# Dressmen Fashion Wear Limited (New)

National Ceramic Industries Ltd, 105-109 Tongi Industrial Area, Tongi, Gazipur.

31<sup>st</sup> January, 2018

# Observations

# Exposed rebar to weather

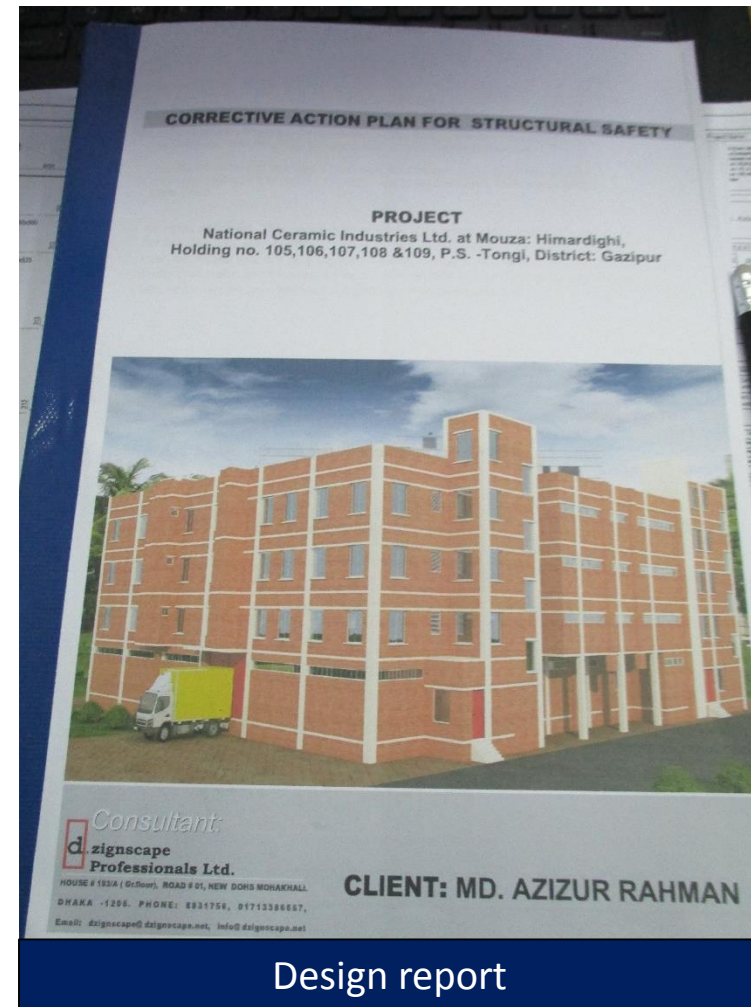
Rebar exposed to weather

Main building will be constructed up to 3<sup>rd</sup> floor in future. Rebar's are left exposed without any corrosion protection. Building engineer is required to provide rust roof coating to the exposed rebar.

| Item No. | Observation                                          | Recommended Action Plan                                                                            | Recommended Timeline |
|----------|------------------------------------------------------|----------------------------------------------------------------------------------------------------|----------------------|
| 1        | Exposed rebar to weather                             | For both durability and serviceability, rust proof paint or any appropriate method is recommended. | 6-weeks              |

# Review design report for extension

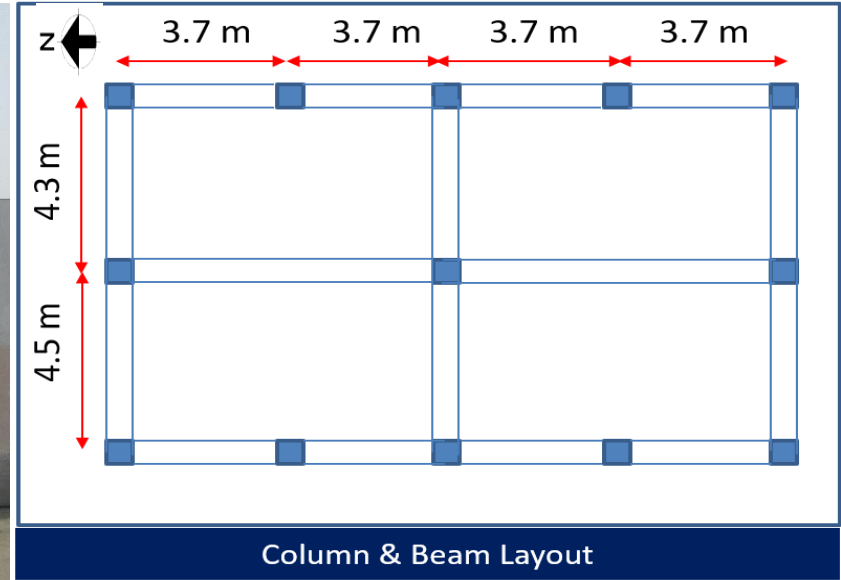
Exposed rebar on roof indication of future extension

In case of any further extension above 1<sup>st</sup> floor, factory is required to review the Design Report with ACCORD and required to follow the recommendations of the Design Report before construction.

| Item No. | Observation                                          | Recommended Action Plan                                                                            | Recommended Timeline |
|----------|------------------------------------------------------|----------------------------------------------------------------------------------------------------|----------------------|
| 2        | Review design report for extension                   | Review the design report with Accord.                                                              | 6-weeks              |
| 3        | Review design report for extension                   | Follow the recommendations of design report before further construction.                           | 6-months             |
